Technical Service Bulletin: TSB230178

Improved Injector Bias Spring: Engine Runs Rough or Misfires

Figure 2, Recon® Injector Serial Number Labelling on Top Stop.

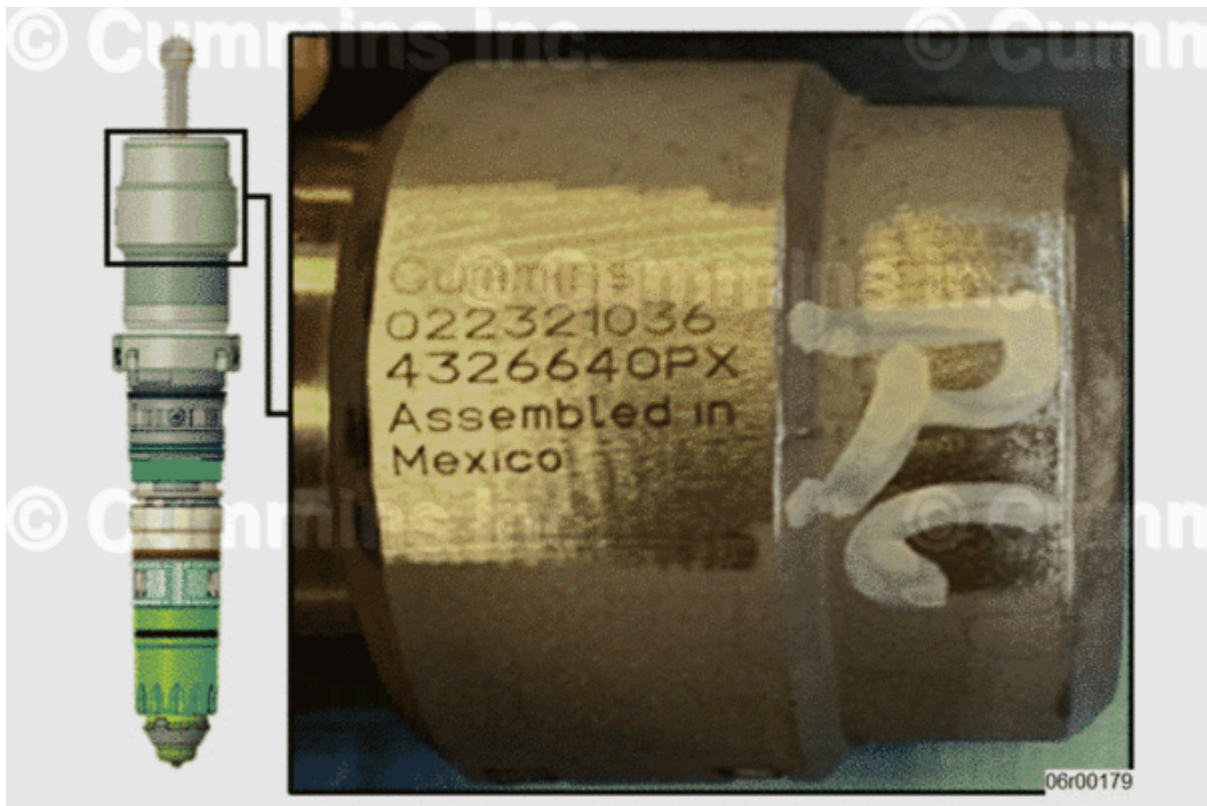
- Any injectors with a serial number between 010120XXX to 020723XXX **must** be quarantined.
